To: INCITS Technical Committee T10  
From: Fred Knight, Network Appliance  
Email: knight@netapp.com  
Date: 17 November 2008  
Subject: SAM-5 - Correct redundant Command State Transition text

Remove redundant text (which is incorrect) from inside a figure, and use just the detailed text already in the document.

Figure 44 — Command states

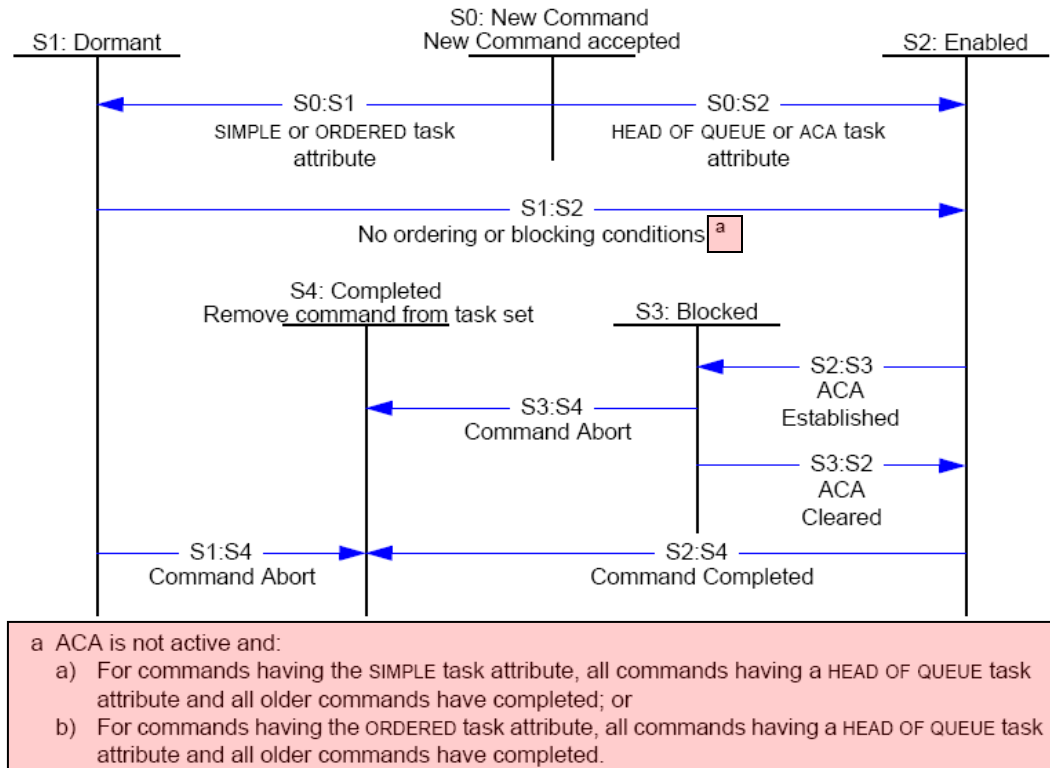
Figure 44 contains text that is inconsistent with text already in the body of the document. The text in the figure should be removed.

Editor's note: remove the red text in the above figure.
